# Beryl Solar Farm Modification 1

Project layout update  
State Significant Development Modification Assessment  
(SSD 8183 MOD 1)

January 2021

**Figure 2 | Approved and constructed project layouts**

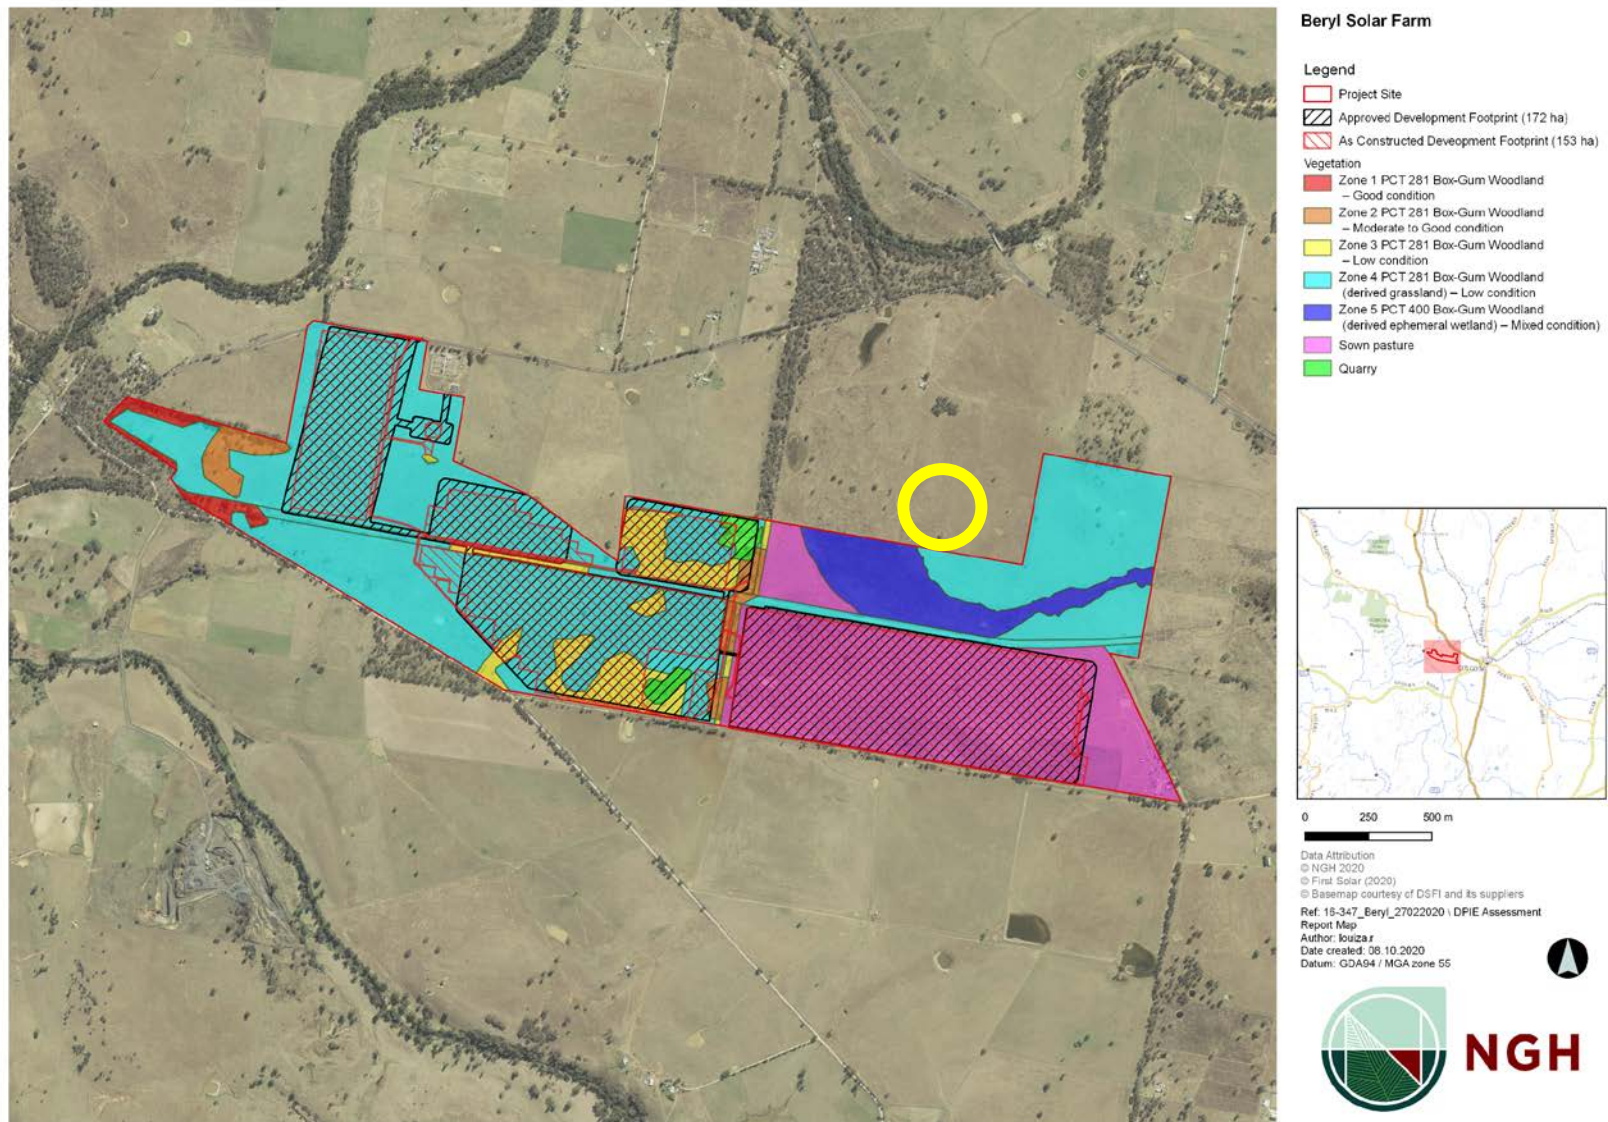
**Figure 2** shows both the approved and constructed project layouts. It also illustrates vegetation zone areas, indicating areas impacted and avoided during project construction, compared with the approved project layout. The project was constructed within the approved development boundaries.

The constructed project avoided areas of Box-Gum Woodland (see **Figure 2**). **Table 2** compares the approved and constructed areas for Box-Gum Woodland and its associated ecosystem credits. The Department supports the changes to avoid Box-Gum Woodland as it is a Threatened Ecological Community (TEC) and results in an improved biodiversity outcome.

BCS is satisfied that the additional areas of impact outside the approved project layout and the excised areas have been adequately assessed. BCS noted that the methods used to determine the amended credit requirement are acceptable and in accordance with the Framework for Biodiversity Assessment, and concurs with the summary of credits listed in **Table 2**. The current consent does not require FS to retire any species credits.
